## Technical note:

# Wylfa Newydd Standby Combustion Plant Environmental Permit Application: Building Sensitivity Analysis Method Statement

1.1.1 This technical note has been produced by Wood Environment & Infrastructure Solutions UK Limited in response to further information requested by Natural Resources Wales (NRW), in addition to the initial Schedule 5 request for more information, following submission of the environmental permit application for the standby combustion plant installation forming a component part of the Wylfa Newydd Project.

Figure 1 Visualisation of various modelled reactor building and discharge location options

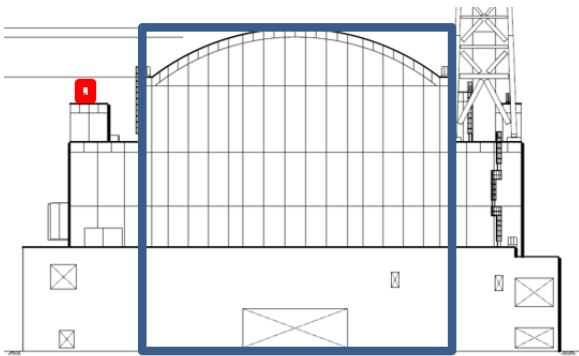
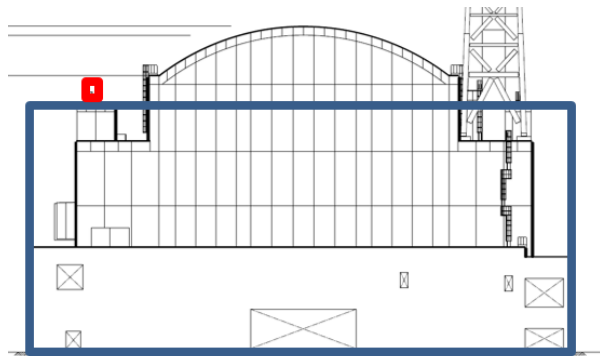
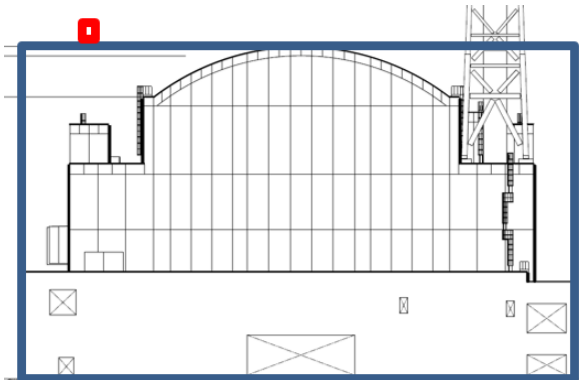
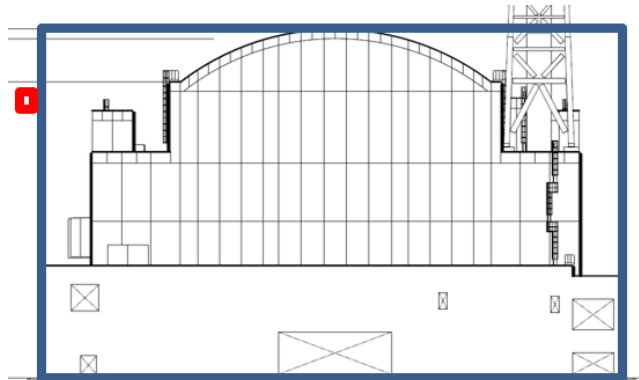
- *Different stack locations relative to reactor buildings (1-101 and 2-101) and receptors;*
- *Varying wind direction to the receptors;*
- *Nearby taller buildings;*
- *Distance and location of modelled stacks to buildings – the shift in stack location may affect the extent of plume entrained in the cavity region which will significantly change the predicted ground level concentration; and*
- *Dimensions of buildings."*

- 3.1.4 Reference is made in Table 1 to various options representing the tiered, curved roof reactor building. These are consistent with the visualisations provided in Figure 2 within the initial Schedule 5 response and have been replicated in Figure 1 of this technical note for ease of reference. Figure 2 provides a visualisation of the current modelled building and emission point layout and identification of building IDs.

Scenario name	Description
<b>Base-case</b>	The existing modelled scenario presented in Appendix H to the permit application. The reactor buildings are represented in the model as per Option 4 in Figure 1 with the reactor buildings (1-101 and 2-101) specified as the 'Main' building for the EDGs. Building lengths and widths modelled at the nominal dimensions in the building parameter plan. Buildings where stacks discharge from, or adjacent to, are modelled at the minimum height of the parameter plan (results in the lowest stack height estimate) whilst all other buildings are modelled at their maximum height. The scenario is modelled using 10 years of hourly sequential meteorological data
<b>Cases to determine sensitivity to different stack locations and distance and location of modelled stacks to buildings</b>	
<b>Sensitivity Case 1</b>	As per the base-case scenario but with the reactor buildings represented by Option 1 in Figure 1

<b>Sensitivity Case 2</b>	As per the base-case scenario but with the reactor buildings represented by Option 2 in Figure 1
<b>Sensitivity Case 3</b>	As per the base-case scenario but with the reactor buildings represented by Option 3 in Figure 1
<b>Cases to determine sensitivity to nearby taller buildings</b>	
<b>Sensitivity Case 4</b>	As per the base-case scenario but with Building 1-102 specified as the 'Main' building for Unit 1 EDGs and Building 2-102 specified as the 'Main' building for Unit 2 EDGs
<b>Sensitivity Case 5</b>	As per the base-case scenario but with Building 0-104 specified as the 'Main' building for Unit 1 and Unit 2 EDGs
<b>Sensitivity Case 6</b>	As per the base-case scenario but with Building 0-109 specified as the 'Main' building for Unit 1 and Unit 2 EDGs
<b>Sensitivity Case 7</b>	As per the base-case scenario but with Building 1-108 specified as the 'Main' building for Unit 1 EDGs and Building 2-108 specified as the 'Main' building for Unit 2 EDGs
